**Pacific Gas and
Electric Company®**

PG&E Letter DCL-13-043

Diablo Canyon Units 1 and 2
Docket No. 50-275, OL-DPR-80
Docket No. 50-323, OL-DPR-82
Supplement to License Amendment Request 11-07, "Process Protection System Replacement"

Figure 4-13 PPS Replacement Communications - Single Protection Set

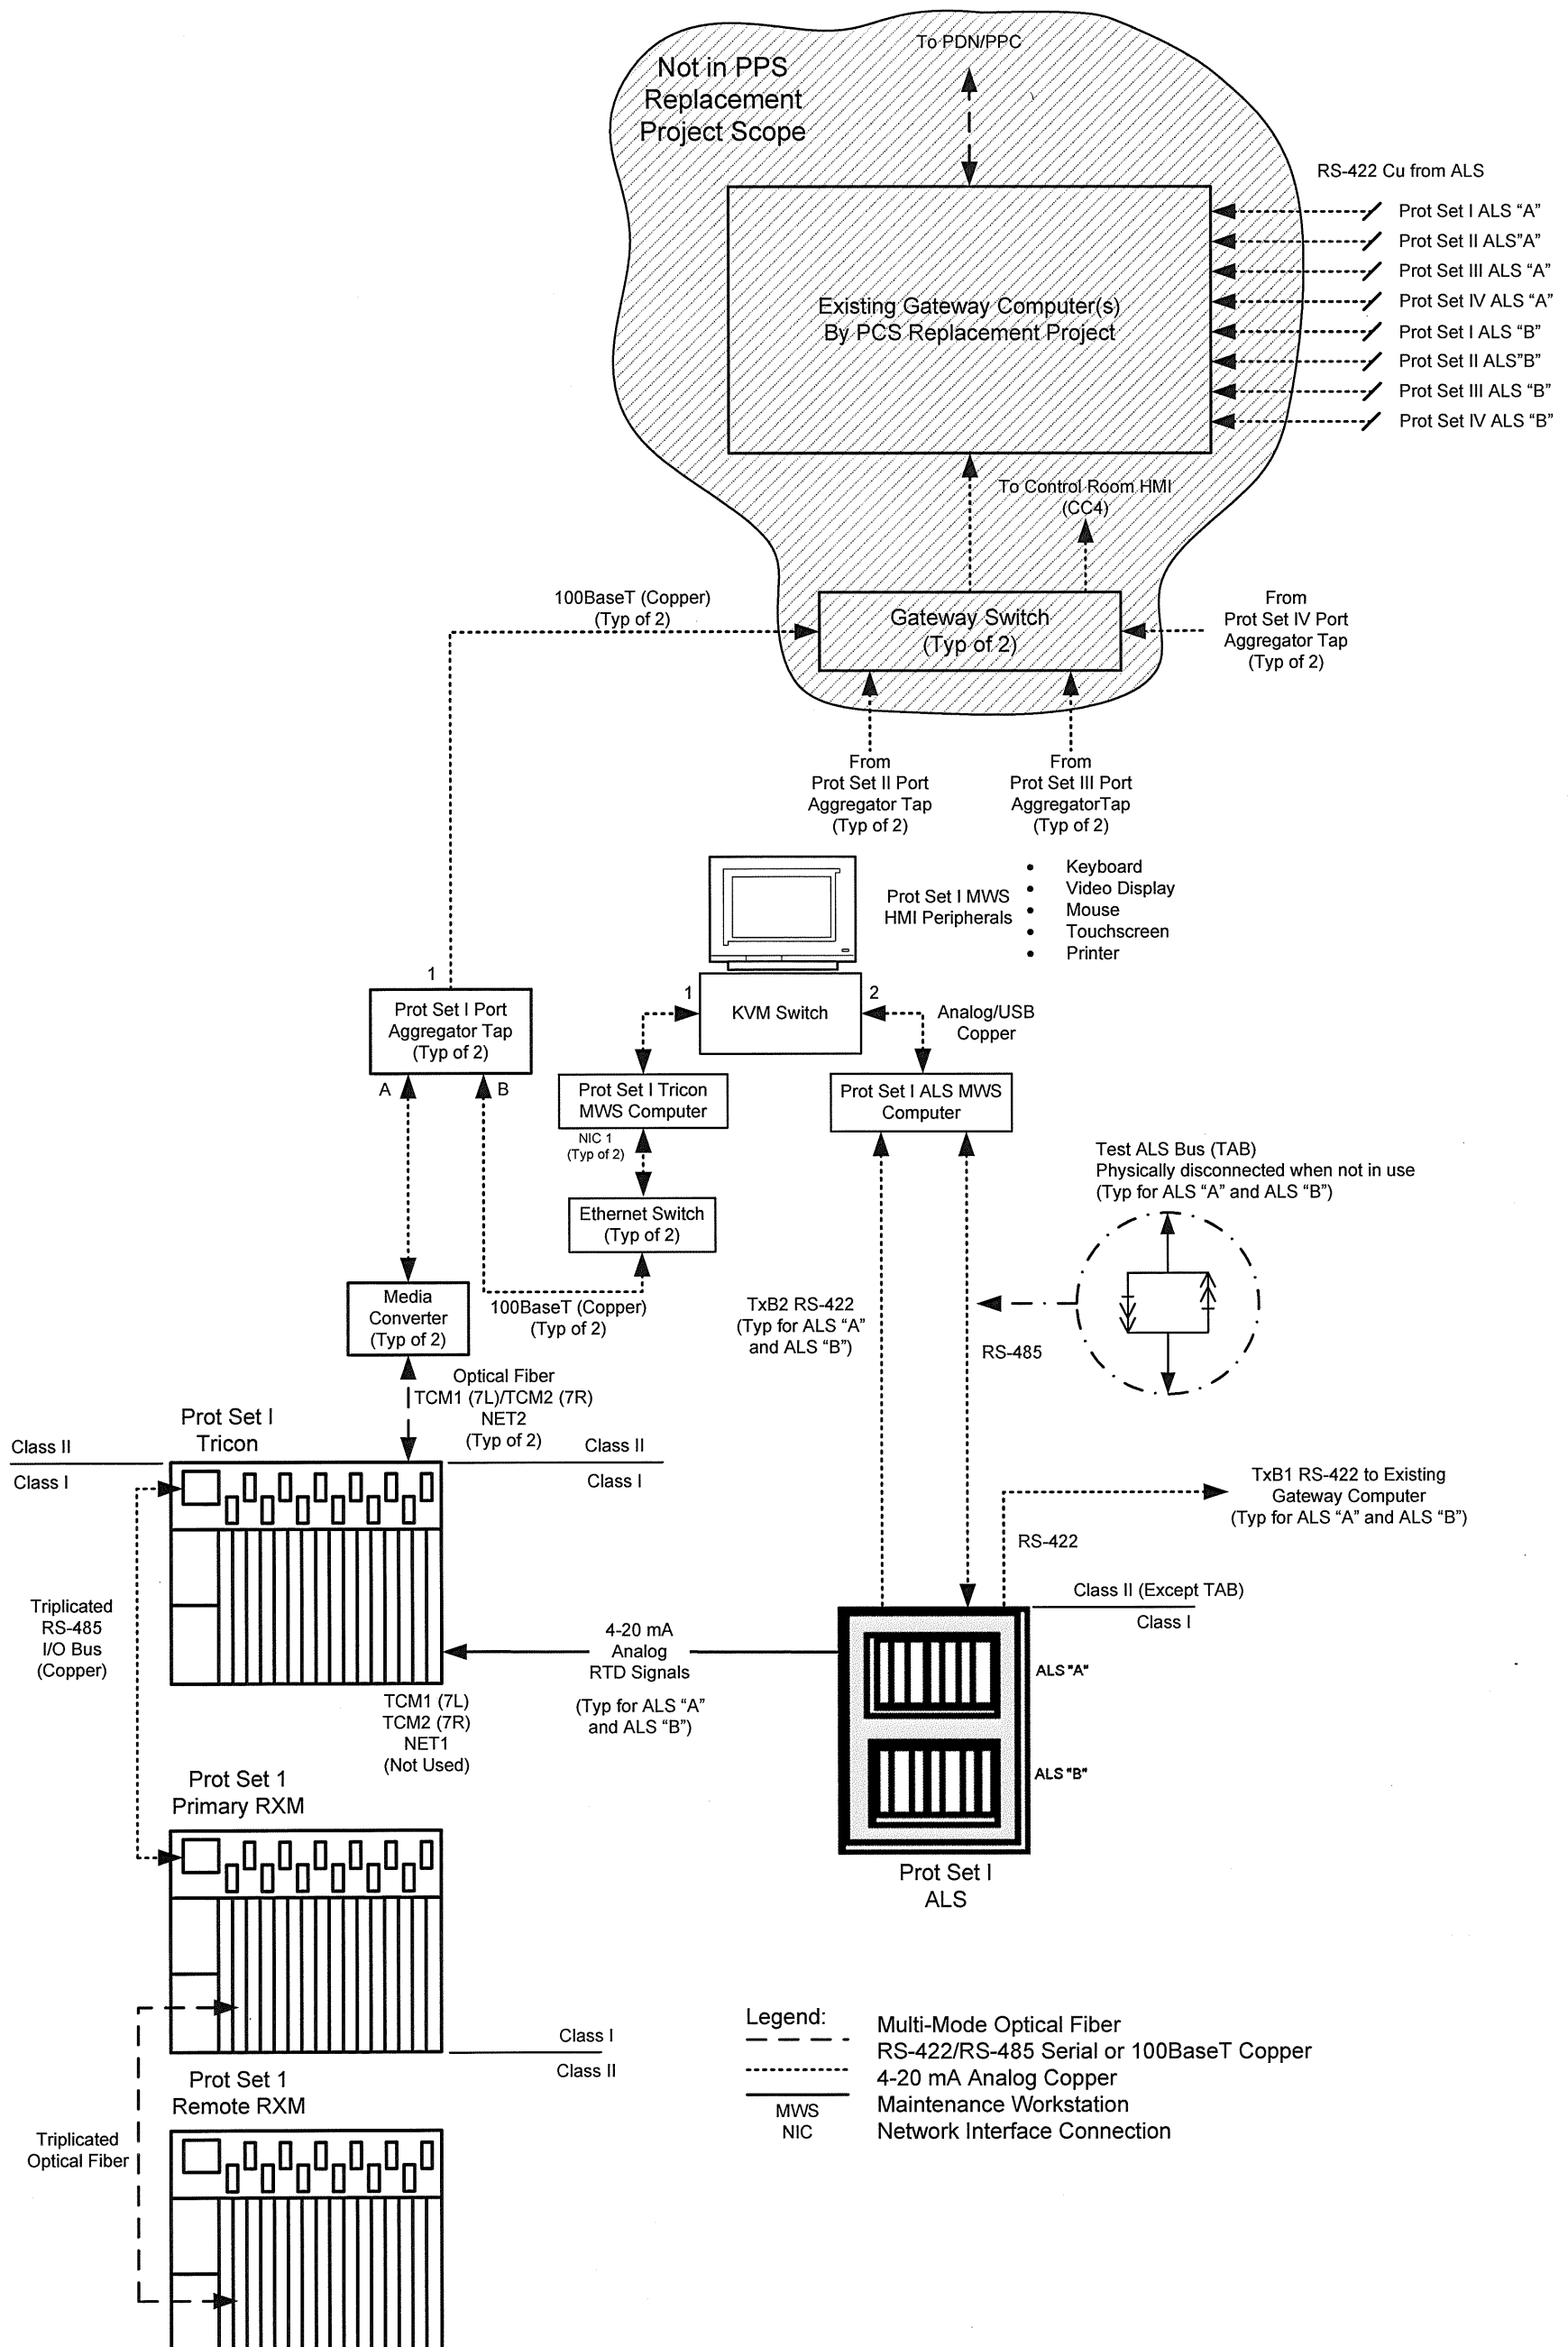
The PPS replacement design incorporates the NetOptics Model PA-CU port aggregator tap device shown in Figure 4-13 to ensure that only one-way communication takes place between the Tricon processors and the PDN Gateway Switch. The port aggregator tap is a hardware device that is installed between the Tricon processor, the MWS, and the PDN Gateway Switch. Ports A and B of the NetOptics are respectively connected to the Tricon TCM fiber optic NET2 port through a fiber optic-to-copper media convertor and directly to the MWS associated with the Tricon via copper Ethernet. The data link protocol from the NetOptics to the MWS and to the TCM media converter is Triconex NET2. The port aggregator tap copies all information that is flowing between Ports A and B to Port 1. Neither Port A nor B can read data from Port 1, and Port 1 cannot transmit data to Port A or Port B.

Figure 4-13 only shows one TCM installed in the Tricon Main Chassis (Slot 7L), the PPS replacement will utilize two TCM cards in each main chassis (Slots 7L and 7-R). This will provide two non-safety-related communication paths to the MWS and the PDN Gateway Switch from each Protection Set to ensure continued communications if a single TCM fails.

During the FAT, Invensys Operations Management will test the Protection Set communications paths illustrated in Figure 4-13 to verify that there is no inbound communications path associated with port aggregator network tap Port 1. That is, Invensys Operations Management will verify that communications from Port 1 to either the TCM on Port A or the MWS on Port B of the port aggregator network tap are not permitted. Results of this test will be documented in the Invensys Operations Management FAT report. Port aggregator dual in-line package (DIP) switch positions will be controlled by DCPD configuration management processes. The Port aggregator DIP switch positions will be controlled by a plant procedure or a plan that will be developed as part of the design change for installation of the PPS replacement after NRC approval of the LAR.
